Access Compliance Report

Public Rights-of-Way

(Curb Ramps)

Intersection ID: 52550	Main Street: MEADOW_BOTTOM_RD	Cross Street: KRISTENS_MARE_DR	Location: E
ADA ID: CF79997F46EB	Ramp Type: PerpDiag	Initial Pass/Fail: Fail	Overall Compliance: No
Codes/Mitigation Info/Possible Solution		Field Measurements/Component Compliance	
Severity Score: 1.25

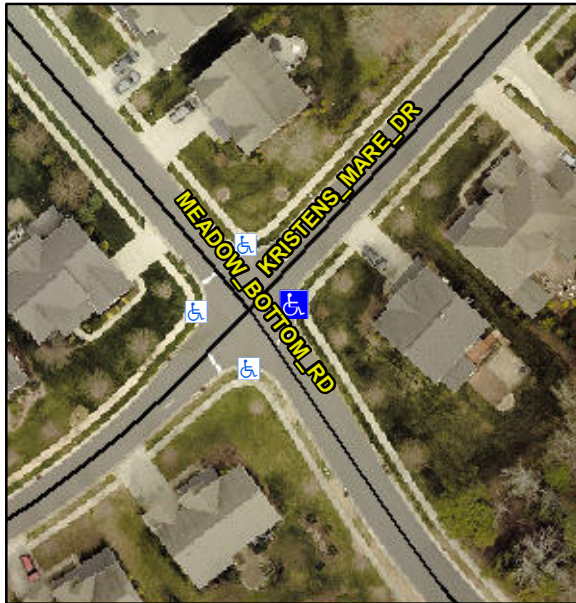
Not Found, R304.5.3

Compliance	Description	Data	Compliance	Description	Data
N/A	Ramp Length (in)	48.0	Yes	Ramp Slope (%)	6.2
Yes	Ramp Width (in)	48.0	No	Ramp XSlope (%)	3.4
N/A	Flare Type LT	N/A	N/A	Flare Type RT	N/A
N/A	Flare Slope LT (%)	N/A	N/A	Flare Slope RT (%)	N/A
N/A	Flare Traversable LT?	N/A	N/A	Flare Traversable RT?	N/A
N/A	Landing Length (in)	N/A	N/A	DWS Provided?	N/A
N/A	Landing Width (in)	N/A	N/A	DWS Contrast?	N/A
N/A	Landing Slope (%)	N/A	N/A	DWS Length (in)	N/A
N/A	Landing X Slope (%)	N/A	N/A	DWS Full Width?	N/A
N/A	Landing Curb? (Y/N)	N/A	N/A	DWS Offset (in)	N/A
N/A	Shared Landing?	N/A			
N/A	Gutter Ponding?	N/A	N/A	Gutter Slope (%)	N/A
N/A	Gutter Lip Ht (in)	N/A	N/A	Gutter X Slope (%)	N/A
N/A	Painted X Walk1?	No	N/A	Painted X Walk2?	No
	X Walk 1 Direction	To NW		X Walk 2 Direction	To SW
N/A	X Walk 1 Width (in)	N/A	N/A	X Walk 2 Width (in)	N/A
	X Walk 1 Slope (%)	1.4		X Walk 2 Slope (%)	1.9
	X Walk 1 X Slope (%)	0.2		X Walk 2 X Slope (%)	4.4

Remove & Replace Curb Ramp With Two New Directional Ramps or Equivalent.
